EL PASO COUNTY HEALTH DEPARTMENT  
COLORADO SPRINGS, COLORADO

SEWAGE DISPOSAL INSPECTION FORM

LOCATION (street number) 20725 Sahara Dr. OCCUPANT Otis Grant

APPLICATION FOR A PERMIT TO CONSTRUCT, REMODEL, OR INSTALL A SEWAGE DISPOSAL SYSTEM

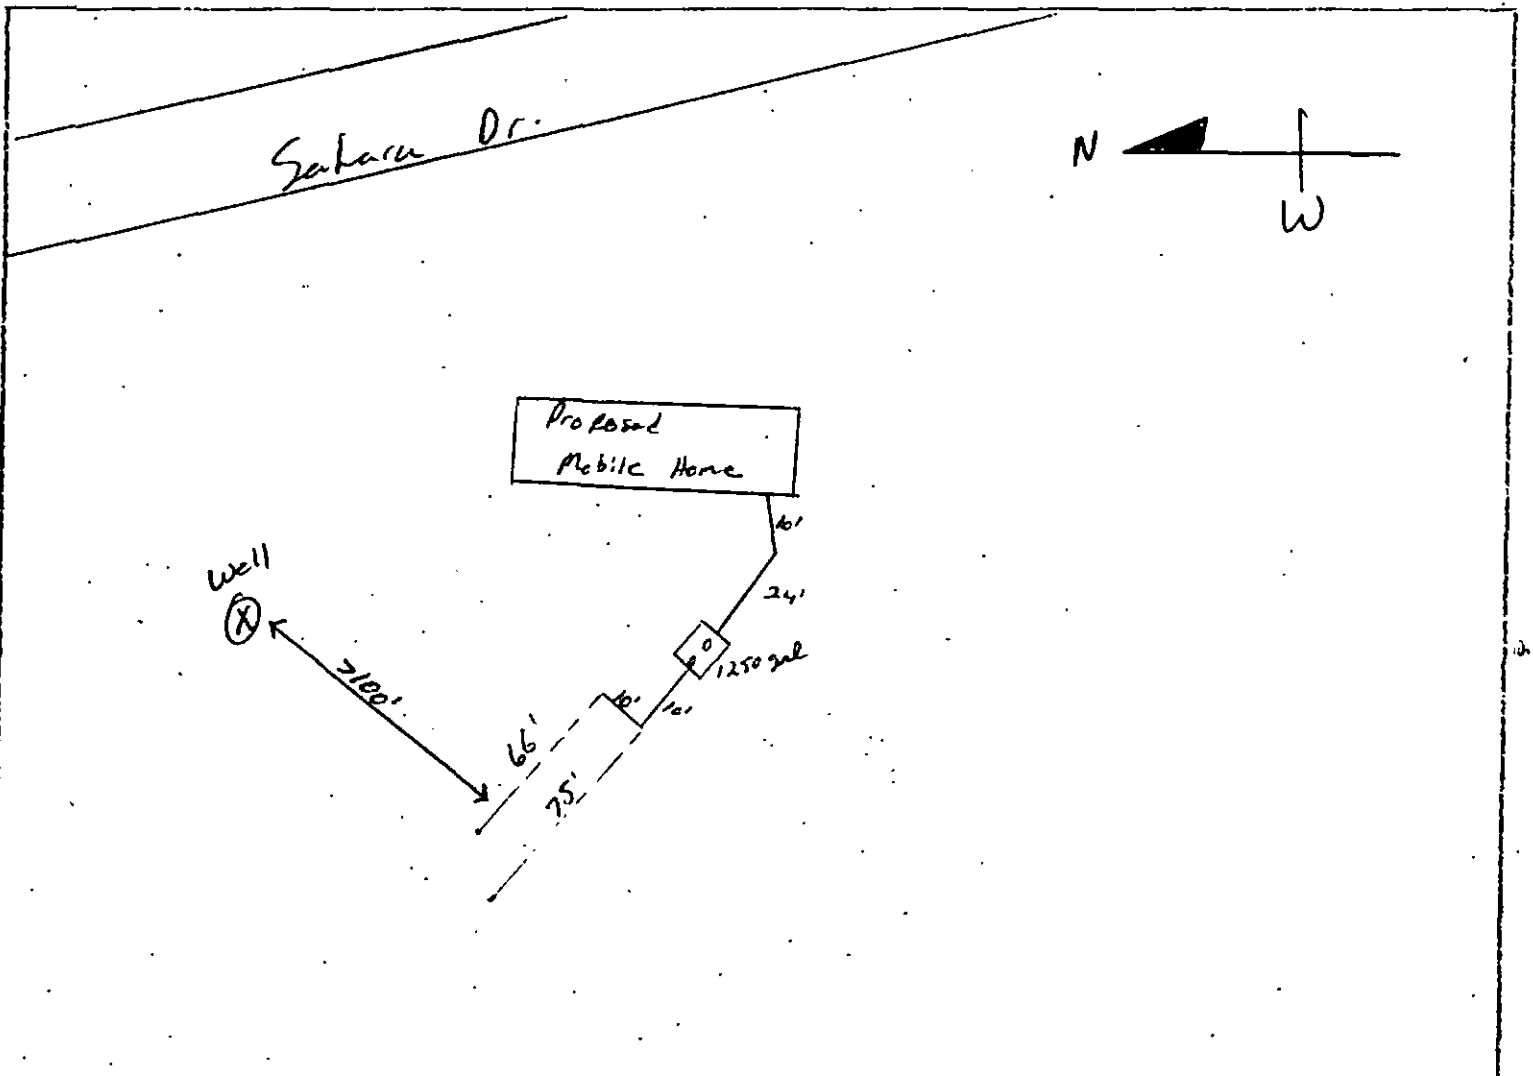
NOTES: Keep septic system 100' minimum from wall. High ground water known to exist in area. If water is found in septic tank hole or in trenches, then work is to stop and this department to be notified immediately.

REMARKS: Keep Septic System 100' minimum from well.

High ground water known to exist in area. If water is found in Septic tank hole or in trenches, then work is to stop and this department to be notified immediately.

Need 125 linear feet of 36" wide trench.
